**Development Application No. DA2023/1869  
Issues response/ Supplementary Statement of Environmental Effects  
Demolition works and construction of a residential flat building  
54-58 Beaconsfield Street, Newport**

Reference is made to Council's issues letter of 27<sup>th</sup> March 2024 in which a number of issues were raised in relation to the proposed development. This submission details the highly considered response to the issues raised and is to be read in conjunction with the following amended/additional plans and documentation:

**Figure 1** – Plan extracts showing portion of eastern wall setback 4 metres from eastern boundary.

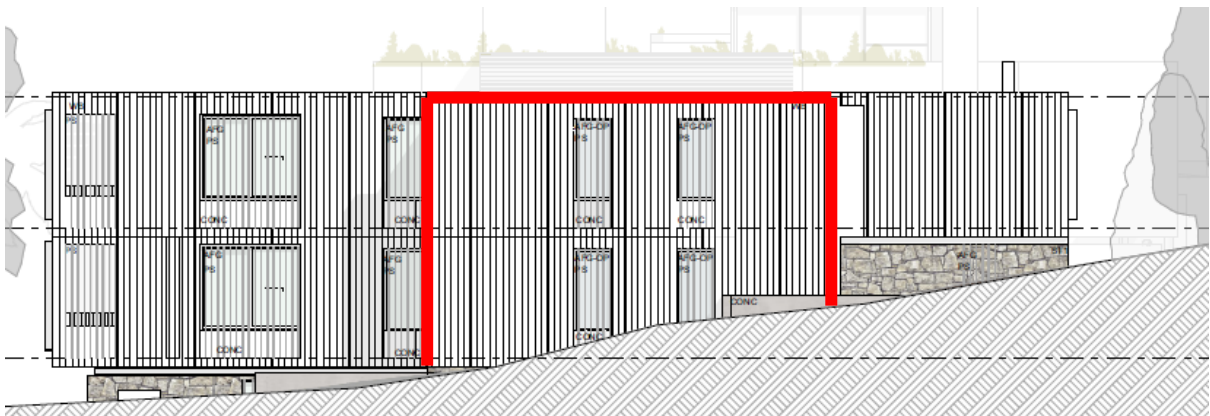
- *The proposed 6m eastern side setback is generally acceptable. However, a portion of this façade is pushed toward the boundary approximately 8.75m long. This wall presents as a large unarticulated mass to a low density residential area and should be set back further or reduced in length to provide an appropriate transition to the low density zoning. This is particularly relevant as this is the only area on site which would provide 6m for deep soil planting without any structures (noting the large amount of retaining walls to the front setback required for the lowered POS areas).*

The section of eastern wall referred to by DSAP is depicted in Figure 1 overpage. Based on a wall height between 5 metres and 6.2 metres for the portion of wall referred to by DSAP the required side boundary setback is between 3.75 metres and 4.05 metres. Accordingly, this portion of wall is compliant with the applicable side boundary setback control.

In relation to the DSAP concern regarding articulation and landscape opportunity we are of the opinion that the variation in the side boundary setbacks, which varied between 4 and 6 metres, provide an appropriate level of built form articulation as it presents to the adjoining R2 Low Density Residential zone with the majority of the façade setback 6 metres, well in excess of the DCP setback provision, in recognition of the sites zone boundary interface.
